W02 / SUBJECT UPDATE 02

Guadalupe Chapel at Galilee | 18 October 2026 HST

Guadalupe Chapel at Galilee, Bigo, Pagbilao

W02 / Option B preferred design direction / 18 October 2026 HST

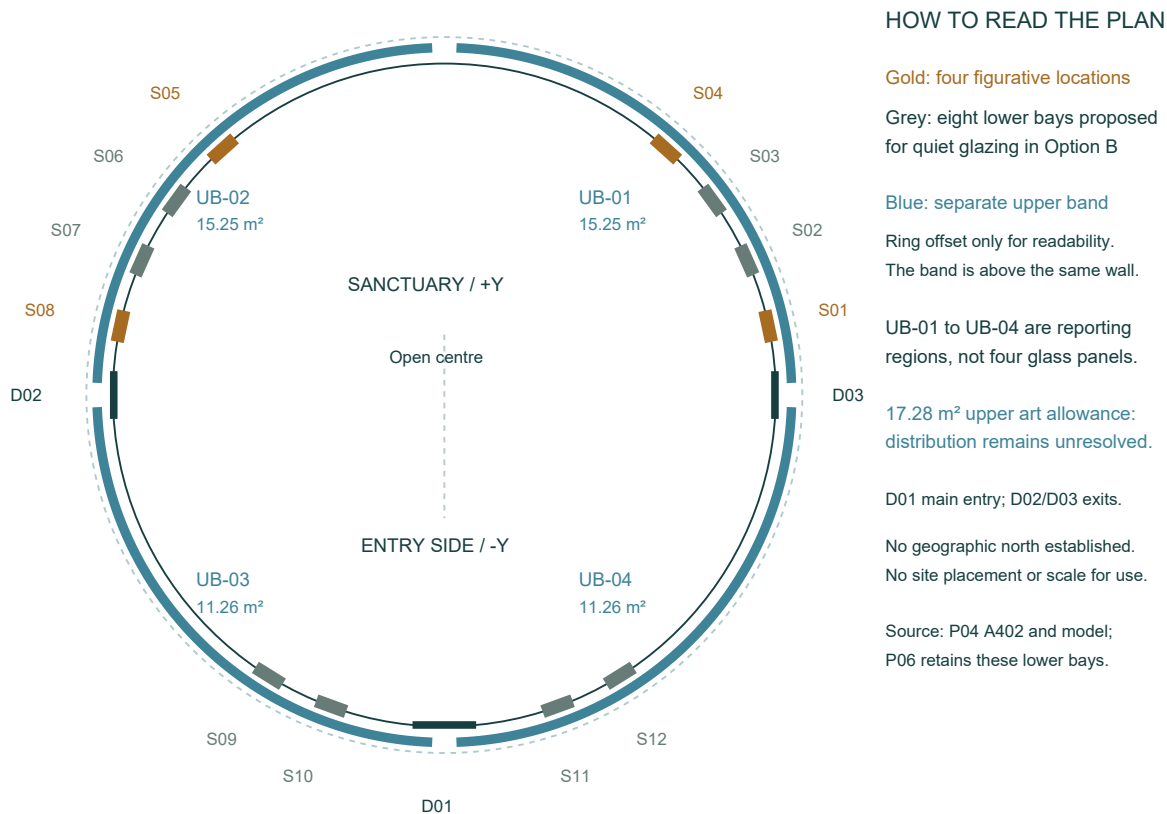
Eight G01 rectangles at 1.20 × 1.80 m do not fit this band upright. The 1.20 m side is also too tall if rotated. At the band height, one 2.16 m² area-equivalent would need roughly 2.70-4.06 m of uninterrupted length before framing. Treat eight as a legacy planning count, not eight fabricated upper panels.

Upper geometric allowance: 17.28 m² gross-equivalent for budget comparison, counted once. **Upper remainder:** 35.73 m² gross for quiet glazing or unresolved interruptions. **Lower quiet bays:** 17.28 m² gross. These remainder areas are not measured clear-glass quantities. Frames, piers, wall/room junctions and services must be resolved before glass is ordered.
